TO: Pedestrian/Bicycle/Motor Vehicle Commission
FROM: David C. Dryer, City Traffic Engineer & Parking Manager
SUBJECT: St. Mary's/South Park Street Reconstruction Project

SUBJECT: St. Mary's Hospital Medical Center

CITY ENGINEERING DESIGN:
ST. MARY'S/SOUTH PARK STREET

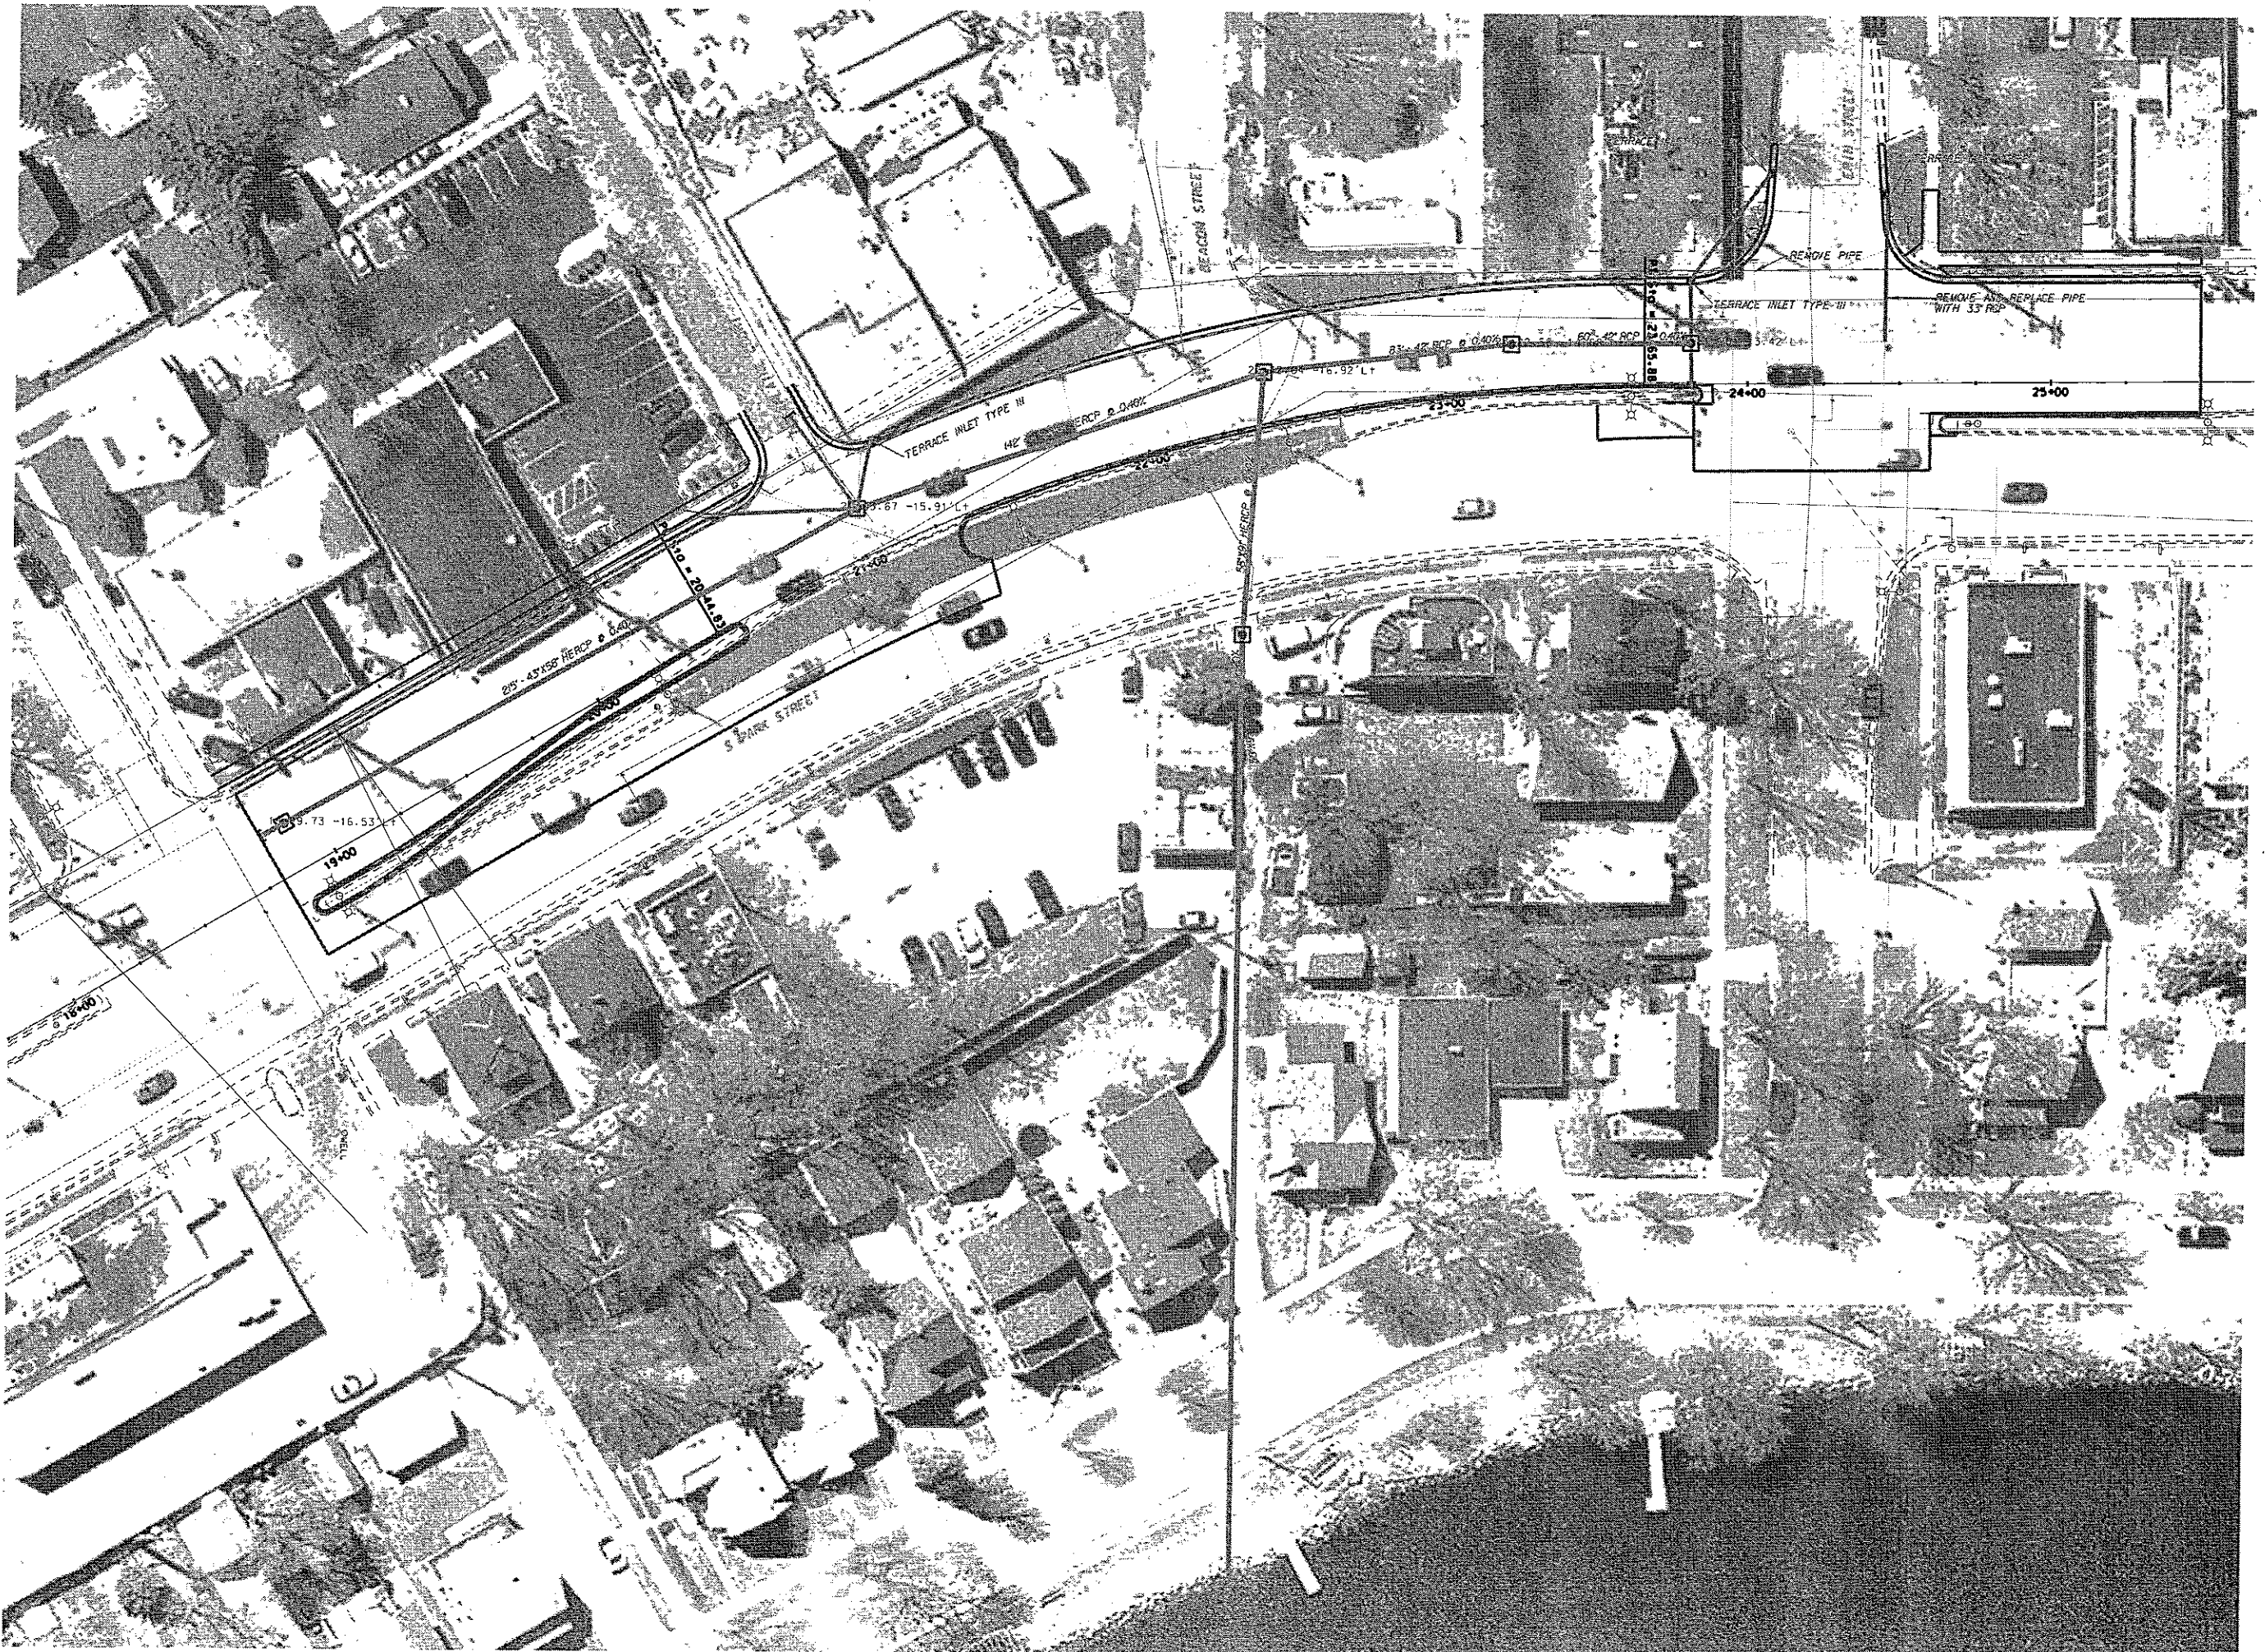
Attached for information are two sketches showing the City Engineering design of Park Street with the storm sewer plan overlaid and a second drawing of the Traffic Engineering design of Park Street. The recommended Traffic Engineering design shows reconstruction in the median along Park Street to provide for the following:

1. Narrowing of the median-side traffic lanes from 11 feet to 10 feet to provide more median space for landscaping, streetscaping and pedestrian refuge crossings. The median noses would be extended and widened from 5 ft to 7 ft.
2. A left-turn in only at Delaplaine Court.
3. The lengthening of the left-turn storage bay at Erin Street.
4. Removal of the exclusive left-turn lane into the Octopus Car Wash for a wider pedestrian and bicycle median refuge at Haywood Drive to cross Park St. Left turns into Octopus would not be restricted. The median nose would be extended and widened from 5 ft to 12-plus ft.
